**CEQA Addendum
Zone 7 Water Agency
Altamont Water Treatment Plant Project –
PG&E Power Pole Relocation**

September 2006

Jones & Stokes. 2006. CEQA Addendum. Zone 7 Water Agency Altamont Water Treatment Plant Project – PG&E Power Pole Relocation. July. J&S 05275.05.

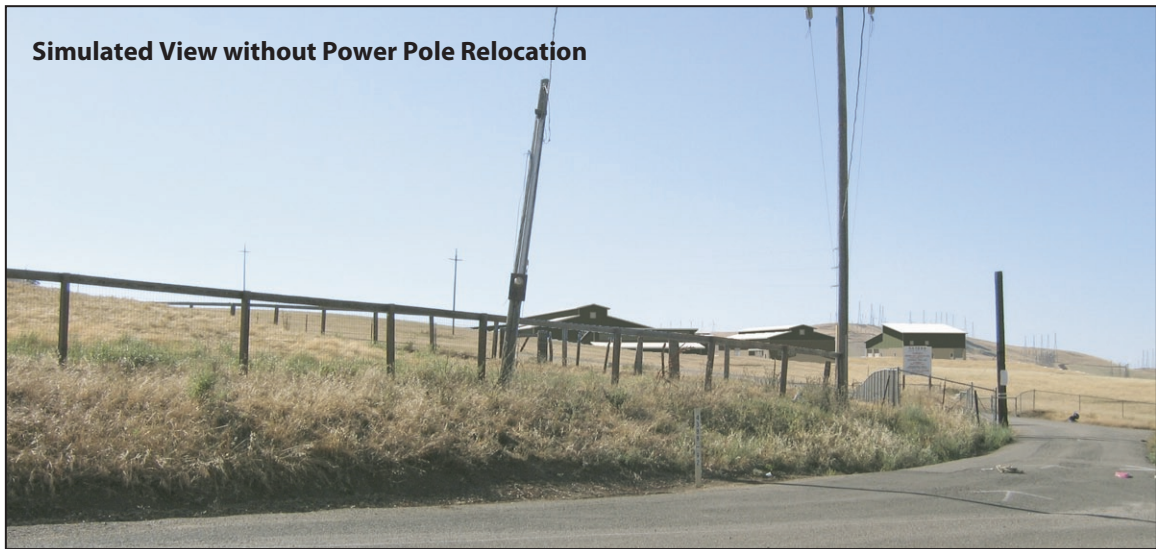
Two existing PG&E power poles would be relocated, and the relocated poles would be of similar material and size as existing poles. A third pole, again of similar material and size may be required. The relocation would move the poles approximately 100 feet closer to the nearest house. (See Figure 1).

The potential aesthetic impact of the relocated poles was assessed by creating visual simulations of relocated poles compared the poles in their current locations. The simulations were based upon photographs taken from the nearest residence from three different perspectives (See Figures 2, 3, and 4). As shown in the figures, relocation of the poles is barely perceptible. Because power poles are a common and existing element of the local landscape, the relocated power line is substantially in the same location as it is at present, the relocation of two poles and the potential addition of a pole would not have a substantial demonstrable aesthetic effect. Although views from Brushy Peak were not simulated, the same conclusion would hold for views from more distant locations, wherein the visual change will be even far less apparent than from the immediately adjacent locations where simulations were prepared.

Aesthetics (Visual Quality)—Conclusion: Impacts of the relocation of PG&E power poles would not result in new or substantially more severe significant aesthetic impacts.
